Appeal of Planning Commission Resolution No. 26-10 Regarding Coastal Development Permit No. 23-034 (33008 Pacific Coast Highway, APN 4473-017-009, Owner Bluff Top 1 LLC, Appellant Mark Mackey) (Continued from September 23, 2026)

Malibu City Council
Special Meeting Agenda

A. Appeal of Planning Commission Resolution No. 26-10 Regarding Coastal Development Permit No. 23-034 (33008 Pacific Coast Highway, APN 4473-017-009, Owner Bluff Top 1 LLC, Appellant Mark Mackey) (Continued from September 23, 2026)

Figure 2: Aerial Map with Blue Line Stream Location

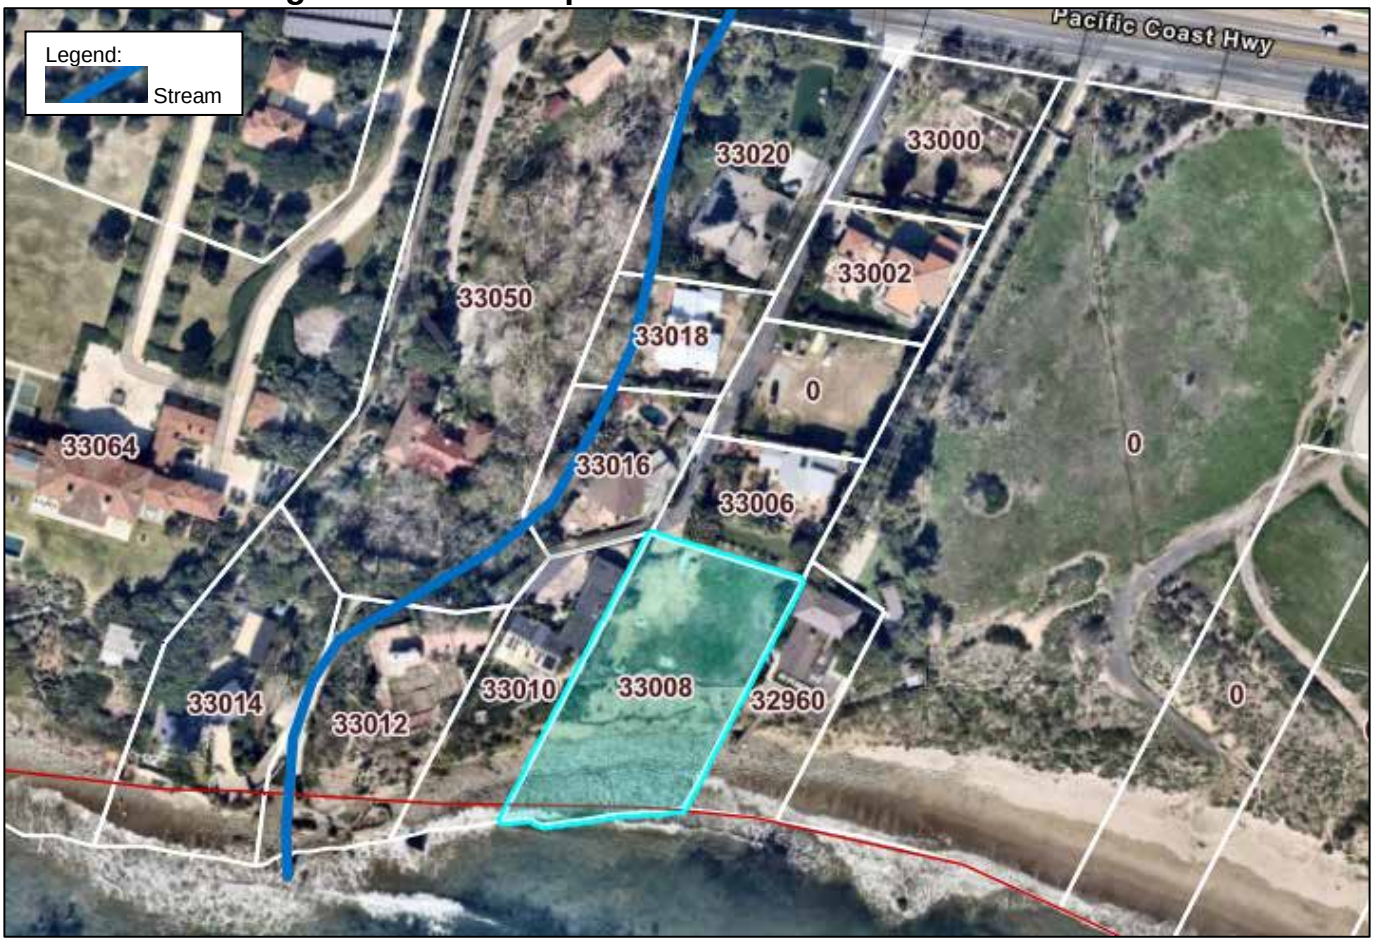
materials and confirmed that the proposed development is located 104 ft. from the mapped blue line stream to the west. It was further confirmed that the project area is located within the existing fuel modification zones of adjacent single-family residences, as shown in Figure 2 below. The figure illustrates that the existing single-family residences and access road are closer to the stream than the proposed project. Nevertheless, the proposed project maintains a 104-ft. setback from the stream, exceeding the required 100-foot buffer. As stated previously, pursuant to Land Use Plan Section 3.1, fuel modification areas required by the LACFD for existing, legal structures do not meet the definition of ESHA. Furthermore, the development is located 100 feet from the stream as required by the LCP, and no new fuel modification encroaches into the ESHA buffer zone.

DRAWING NO.
A-0.3

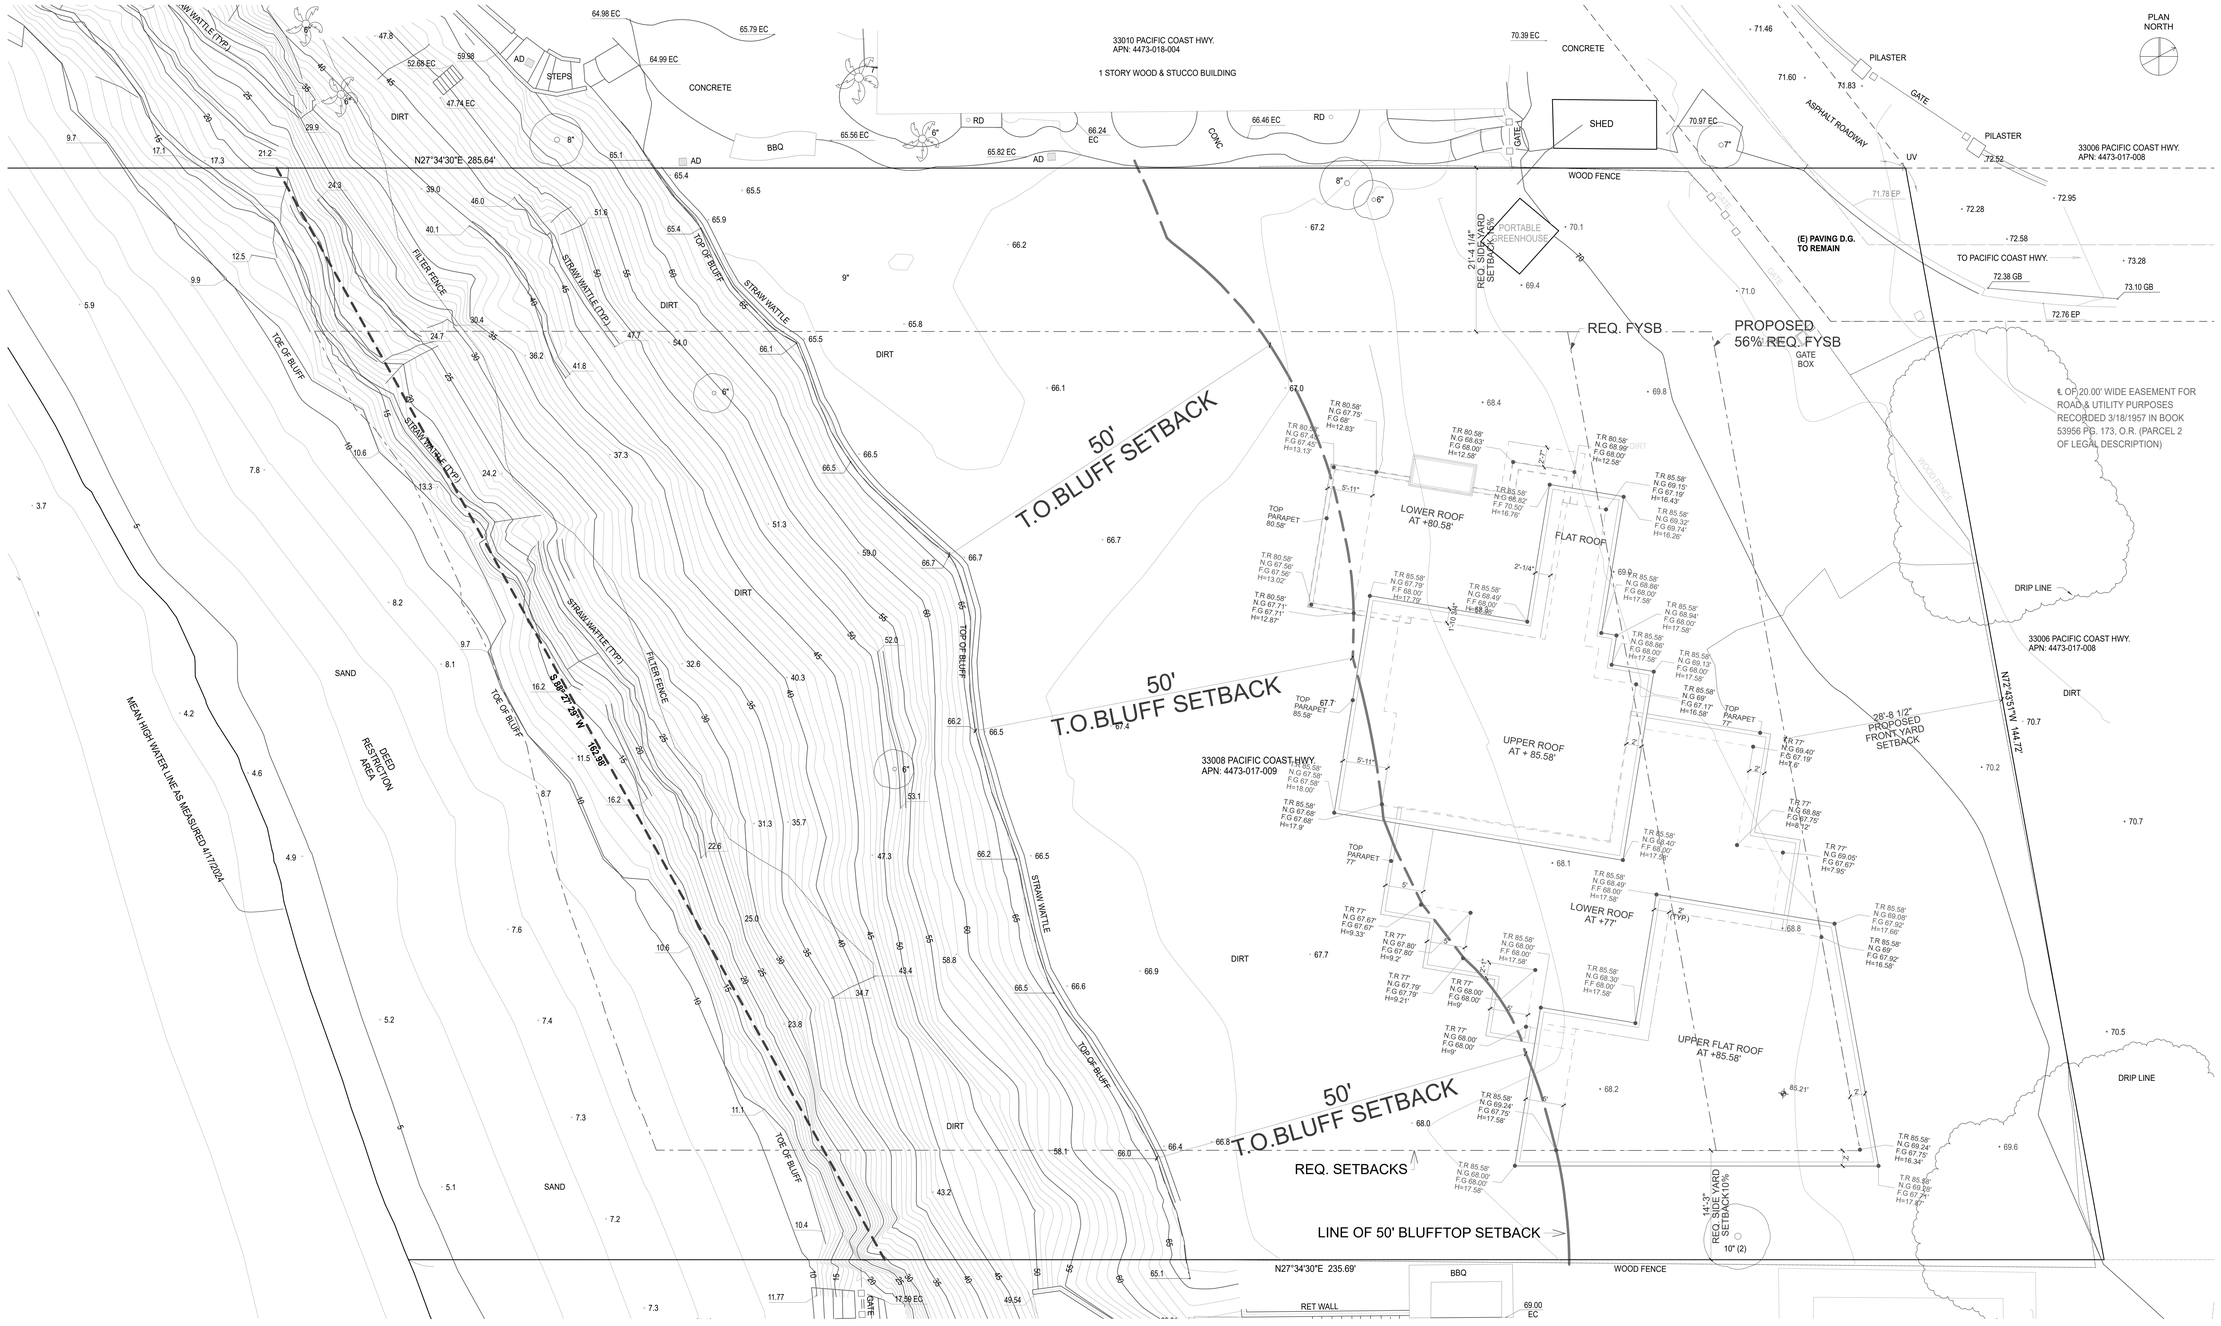
As shown on the Project Plans, the Project lies partially within an ESHA buffer. (See, e.g., Plan Sheet A-0.2, showing new planters, gates, walls, pilasters, and fencing located behind a line labeled "approx. 100' from ESHA boundary.") Our Clients' biologist team, Amigo Environmental, LLC ("Amigo"), prepared a peer-review of the Applicant's biological assessment (the "Amigo Report"), attached as **Exhibit A**, which likewise states that "at least a portion of the subject property and proposed Project may be located within an ESHA buffer and/or within 100 feet of protected of riparian habitat." (*Id.* at 4.) Accordingly, the Project must comply with the development-area limitations that apply to such projects. Indeed, Applicant admits as much by purporting to demonstrate compliance with the development area limitation on Sheet A-0.3 of the Plans. (See Sheet A-0.3, below, marked-up.)

Here, the Applicant purportedly demonstrates compliance with the development area limitation on Sheet A-0.3, showing a total development area of 9,652 square feet. (See Plans, Sheet A-03.)

and driveway, planter boxes, and landscaping. A marked-up Sheet A-0.3 (Site Plan), below, shows this issue:

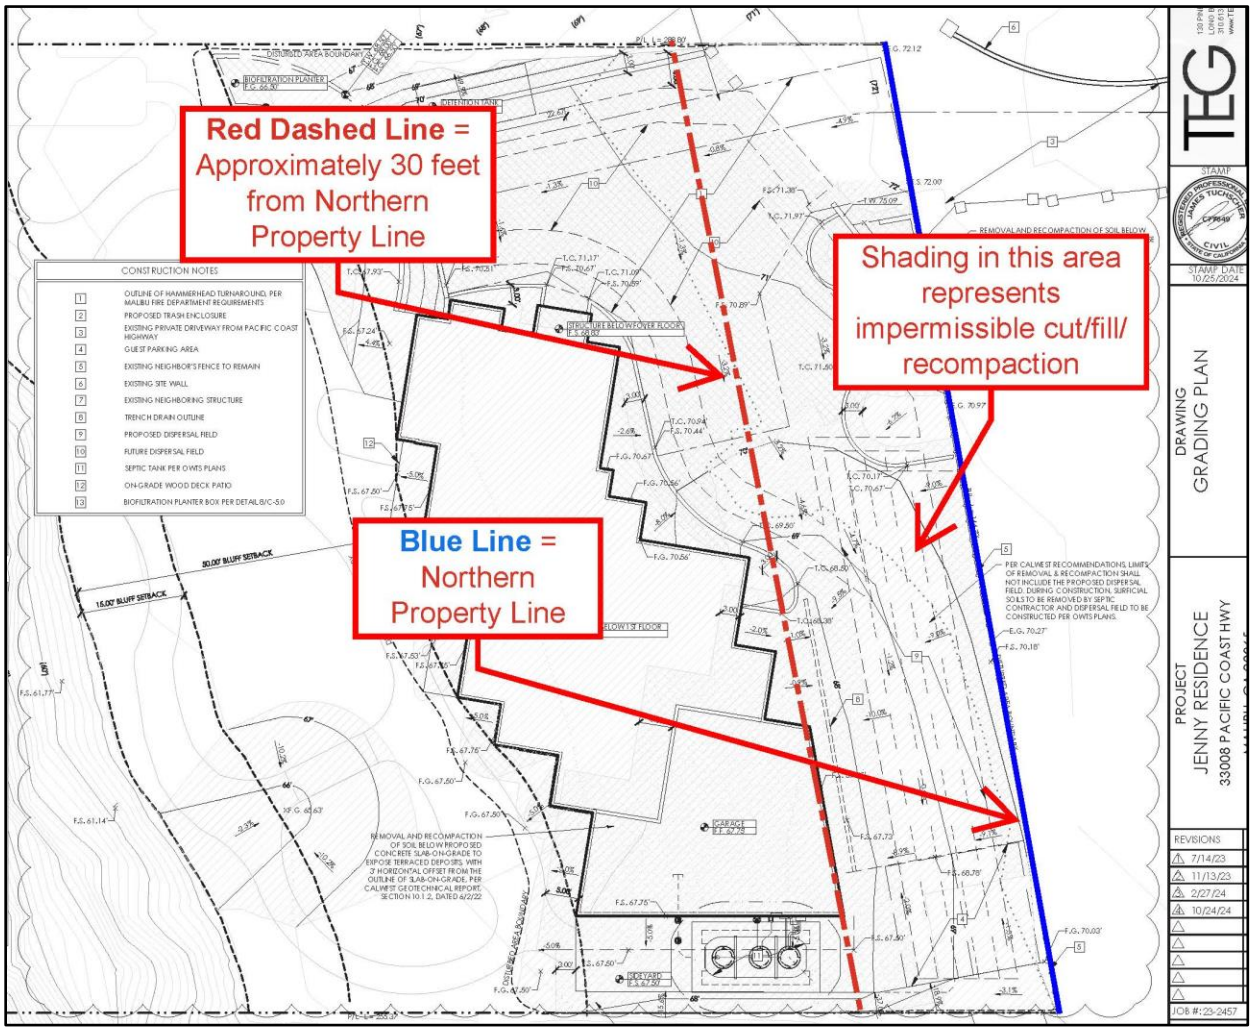
- Finally, the Applicant offers no competent evidence of surrounding fuel-modification zones. Its crudely drawn map in an email memo lacks a legend, scale, or verifiable methodology and cannot serve as substantial evidence to rebut the biological and ESHA findings discussed above.

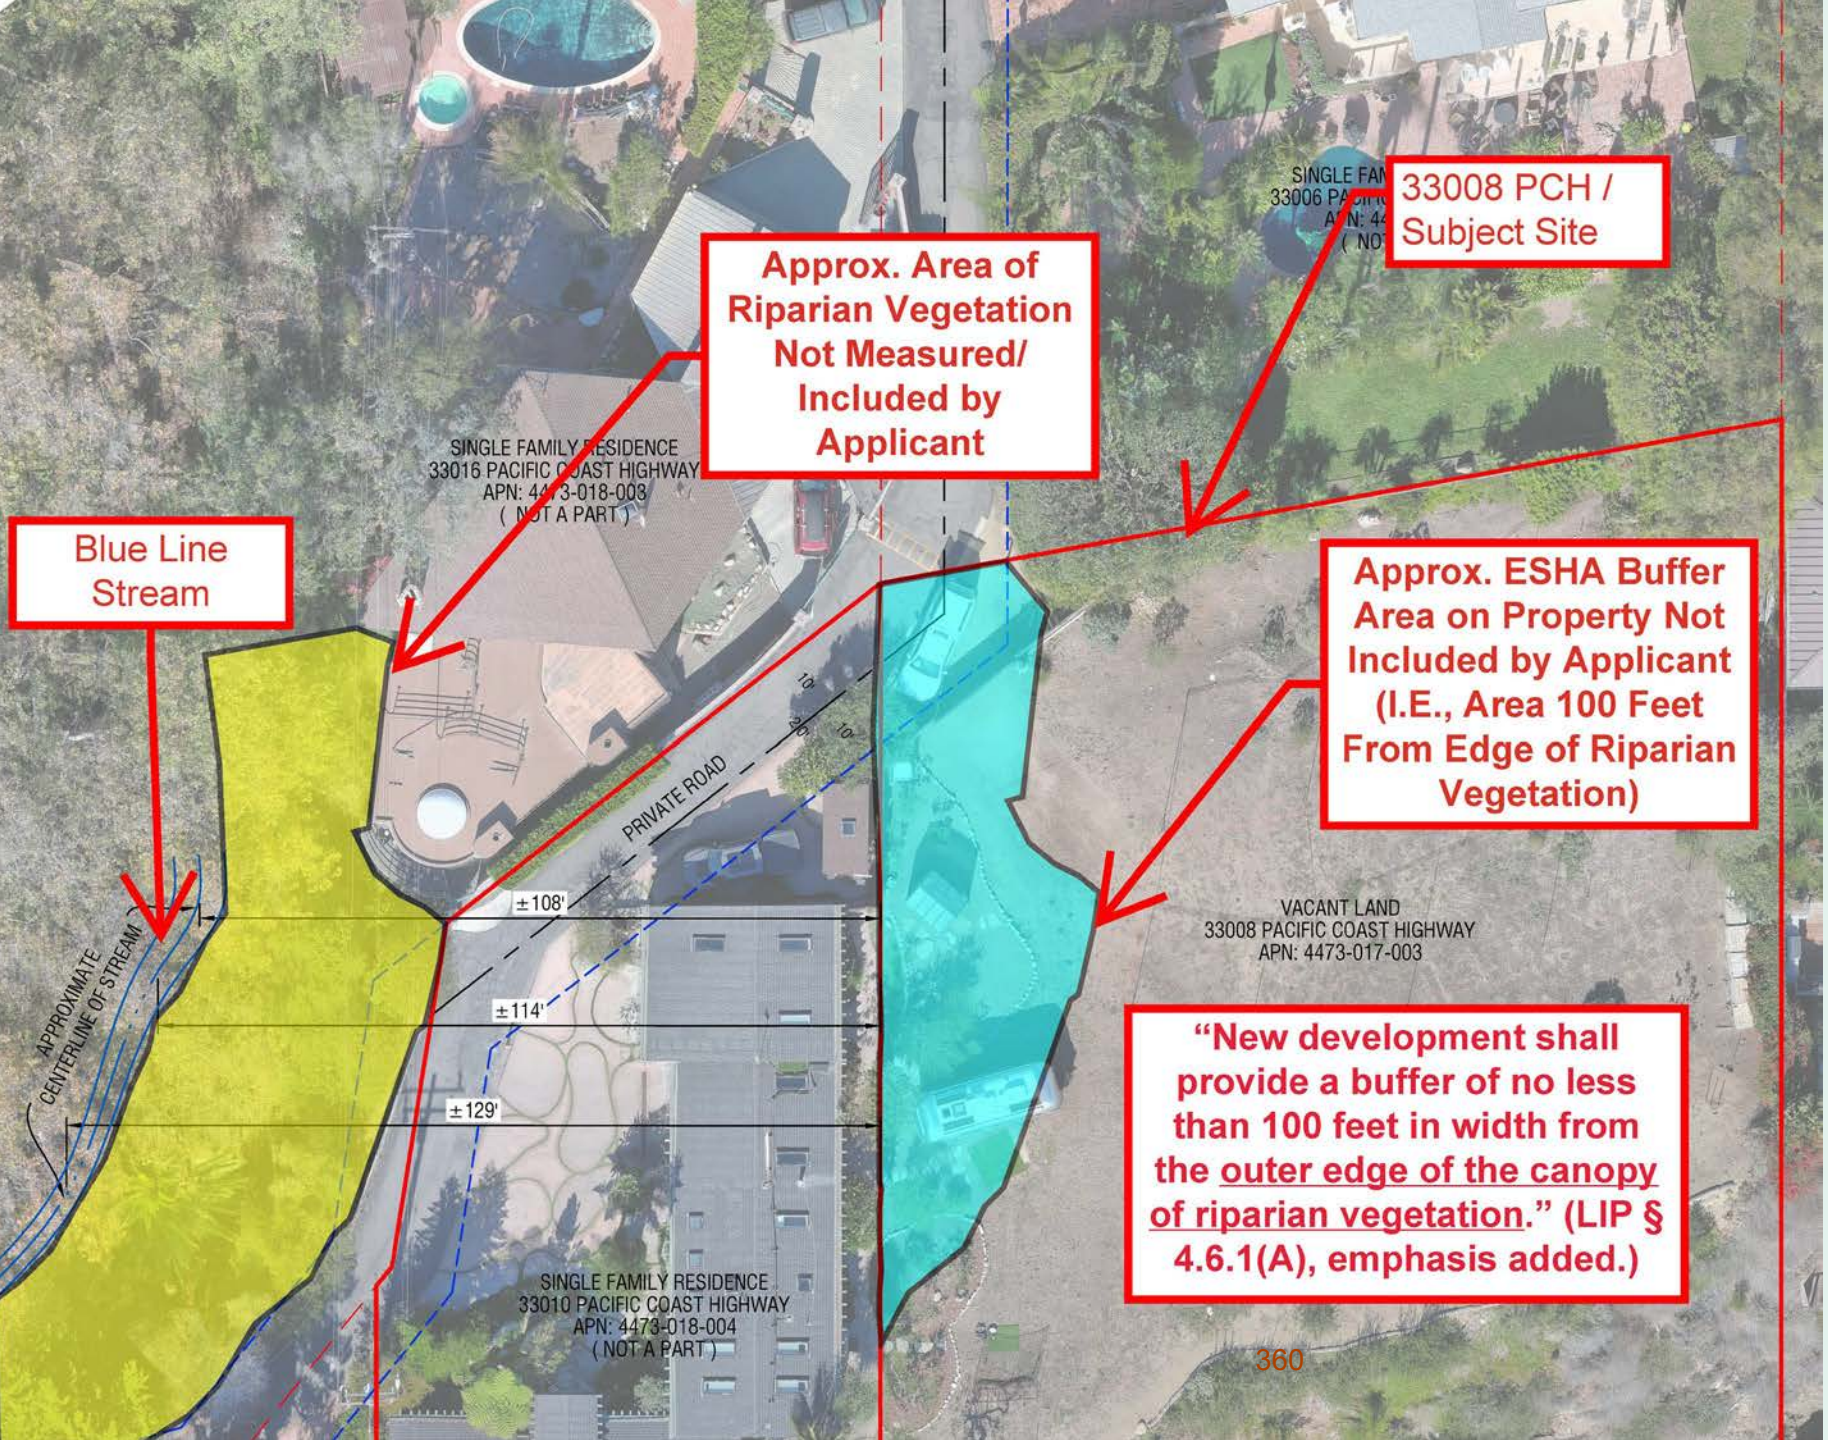
But the LIP requires development to be at least 100 feet from the edge of the riparian vegetation, not the top of the stream bank. The LIP states:
